Revisions to the Phase I Interim Report and Phase II Proposal

**CIBA-GEIGY Facility
Cranston, Rhode Island**

July 1993

TECHNICAL REVIEW - PHASE I INTERIM REPORT AND PHASE II PROPOSAL

DR. BY:	DRS	SCALE:	1:1200	PROJ. NO.:	87X4660
CKD. BY:	PN	DATE:	21 OCT 1991	FIGURE NO.:	4-2
REVISION NO. 1 7 JULY 1993

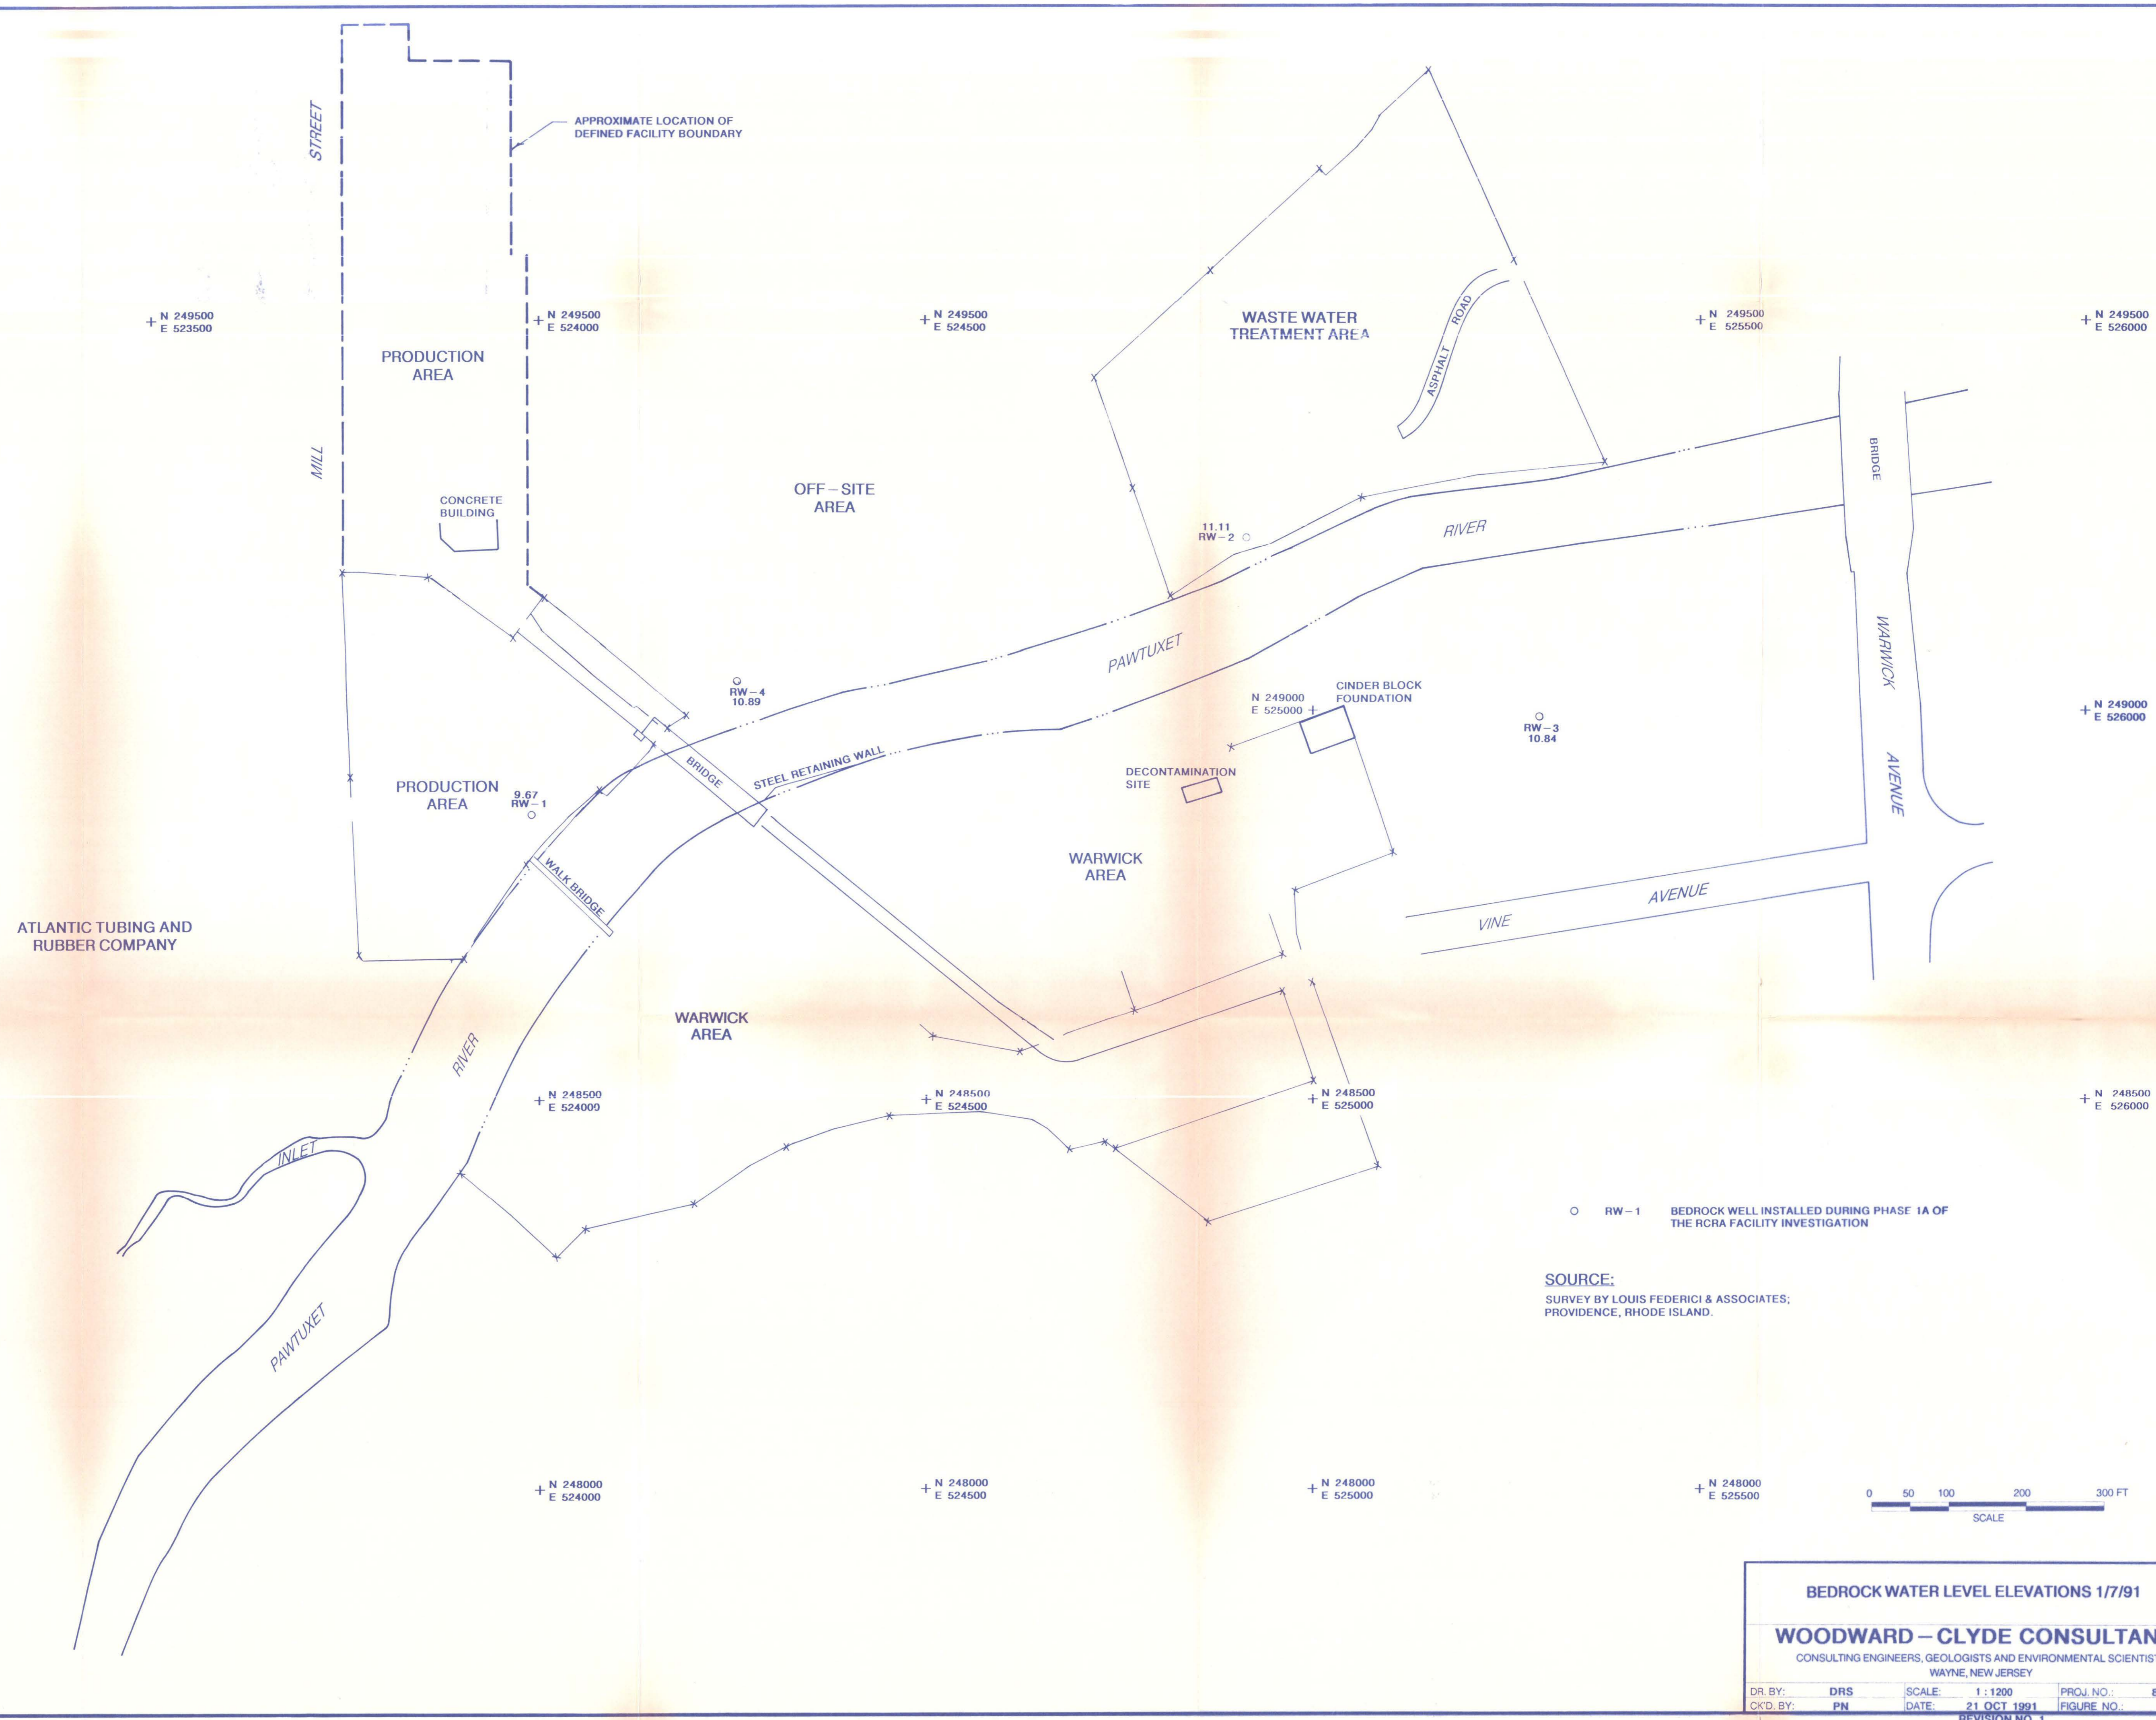
8. **Figure 4-2:** The value for RW-1 (9.17 feet) does not agree with the value shown on table 4-4. This should be corrected.

The elevation for bedrock well RW-1 was mislabelled. The correct elevation is shown in revised Figure 4-2.

DR. BY: KF	SCALE: 1:1200	PROJ. NO.: 87X4660
CKD. BY: JD	DATE: 21 OCT 1991	FIGURE NO.: 4-5
REVISION NO. 1 7 JULY 1993

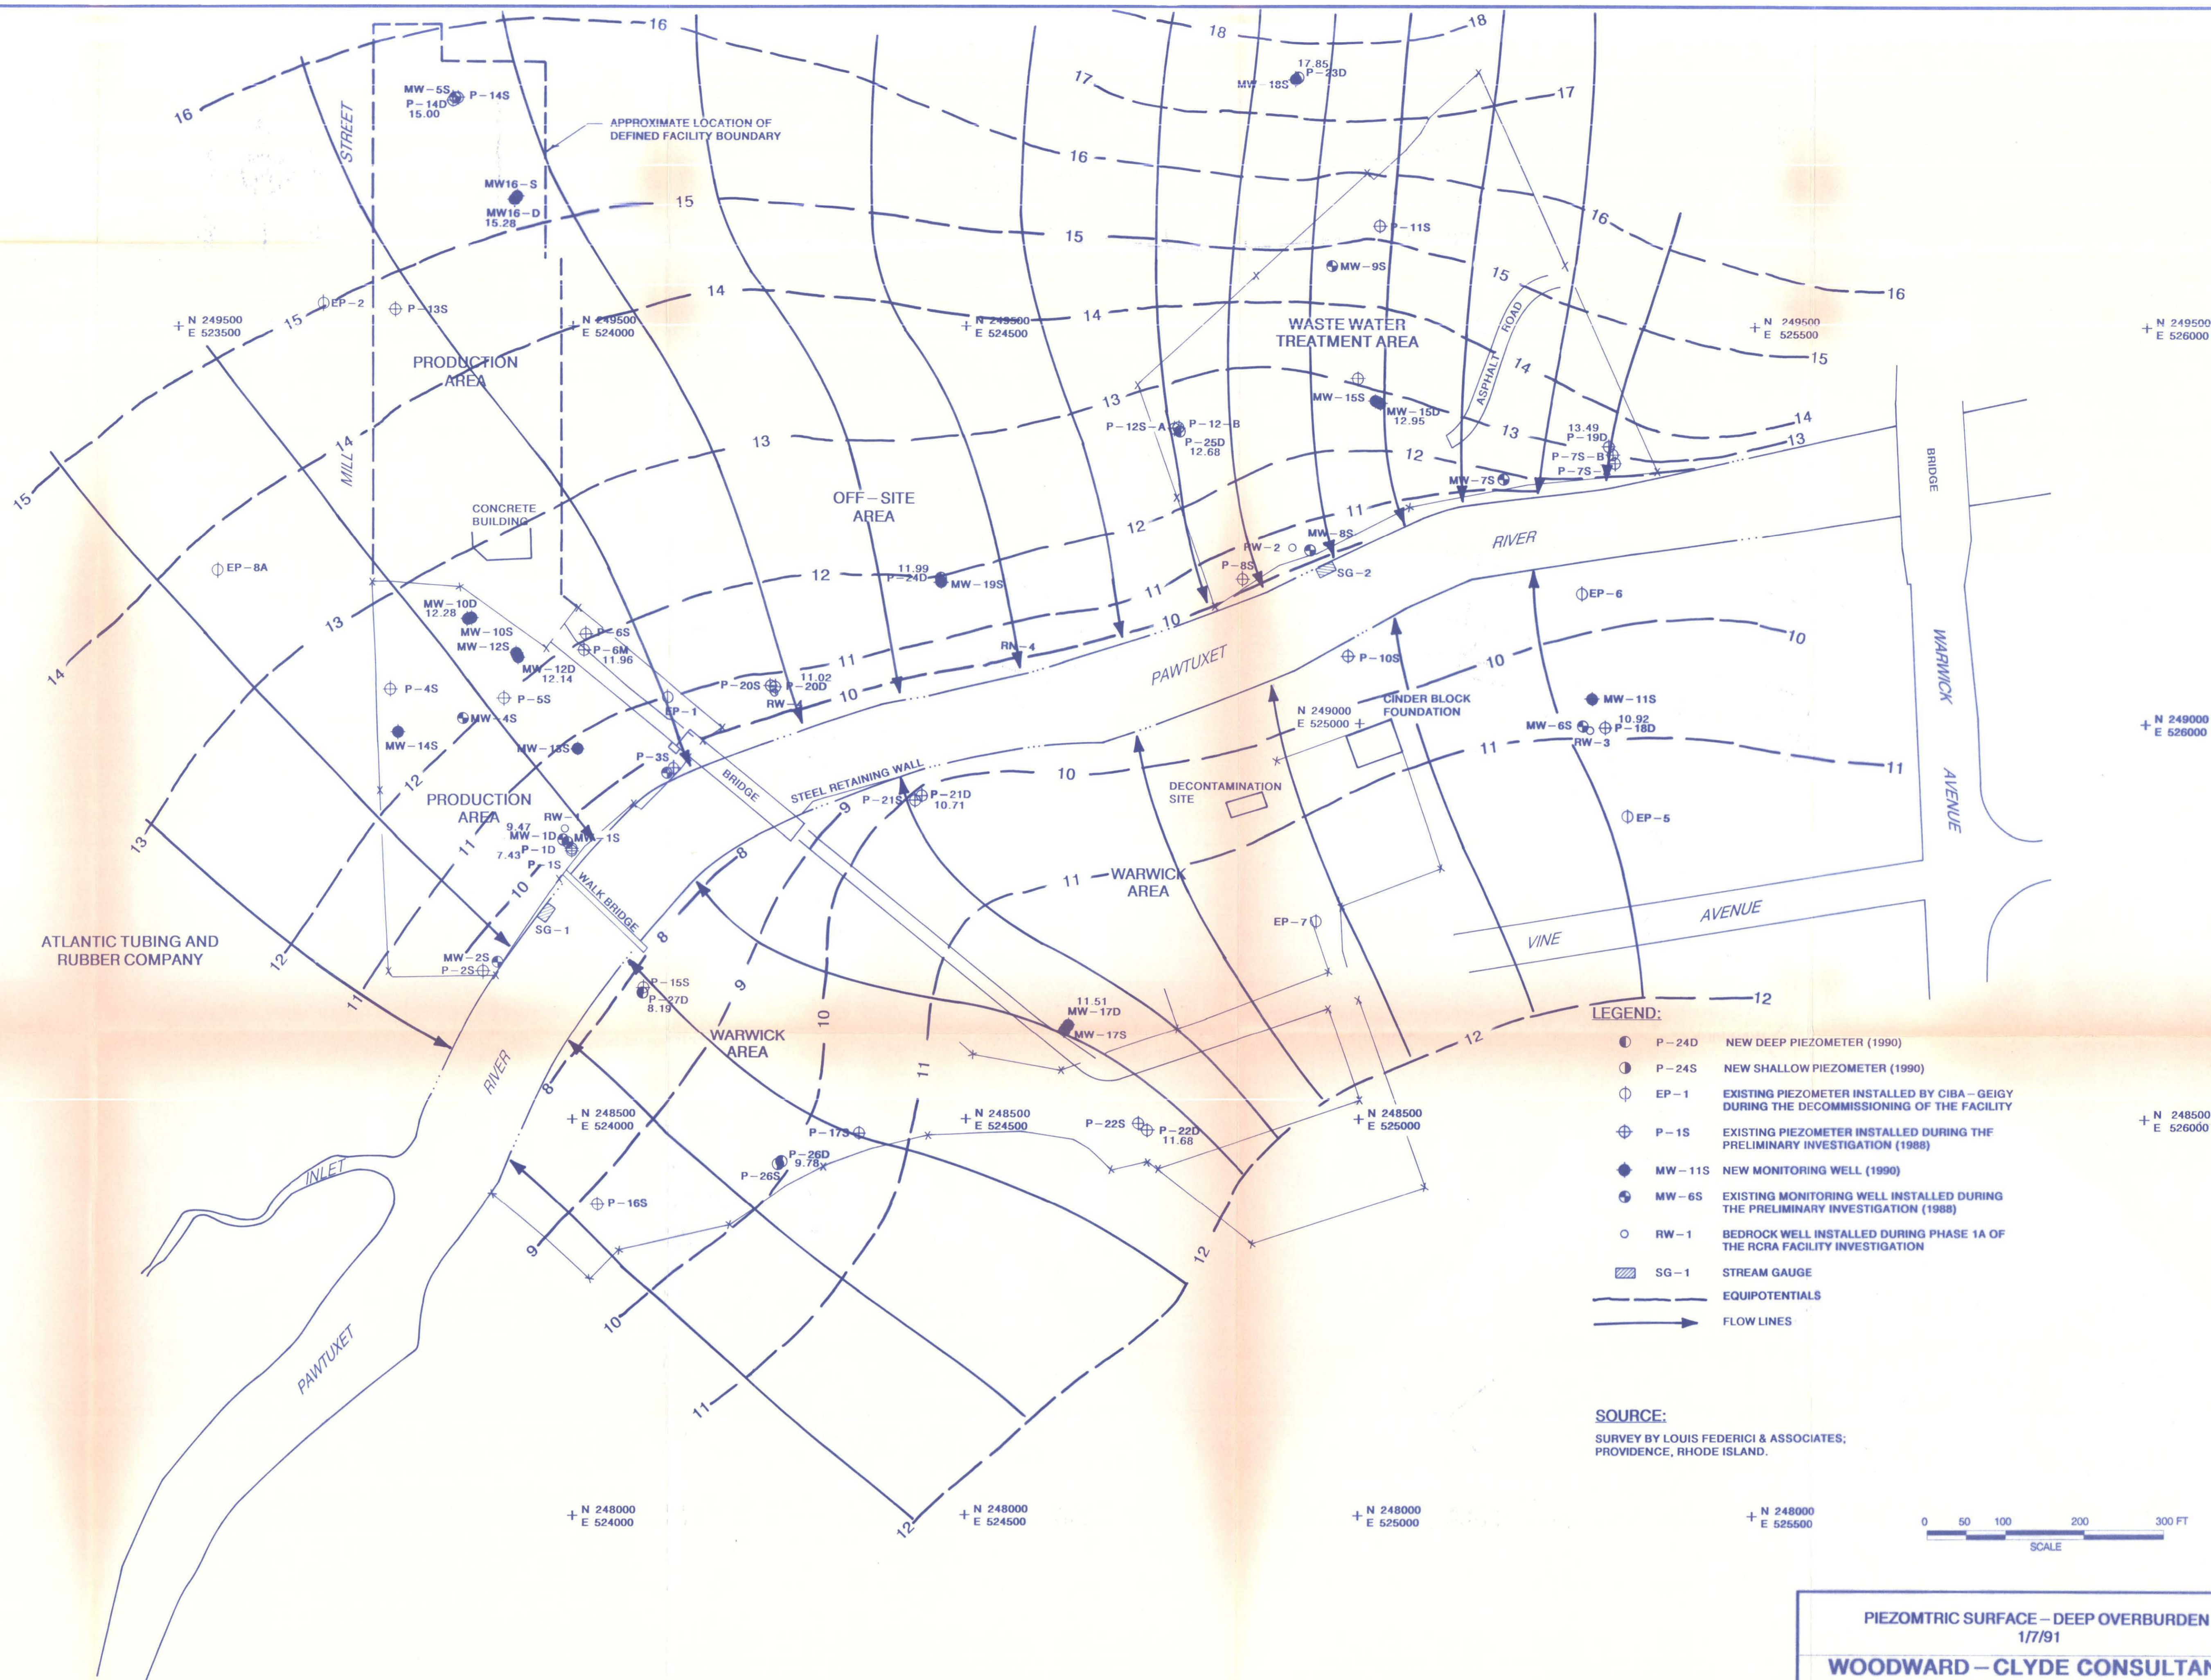
6. **All Figures:** All figures should indicate the date for which the water levels represent and have the numerical data points on the figure.

Water level data and the dates these measurements were taken have been added to revised Figures 4-3 and 4-5.
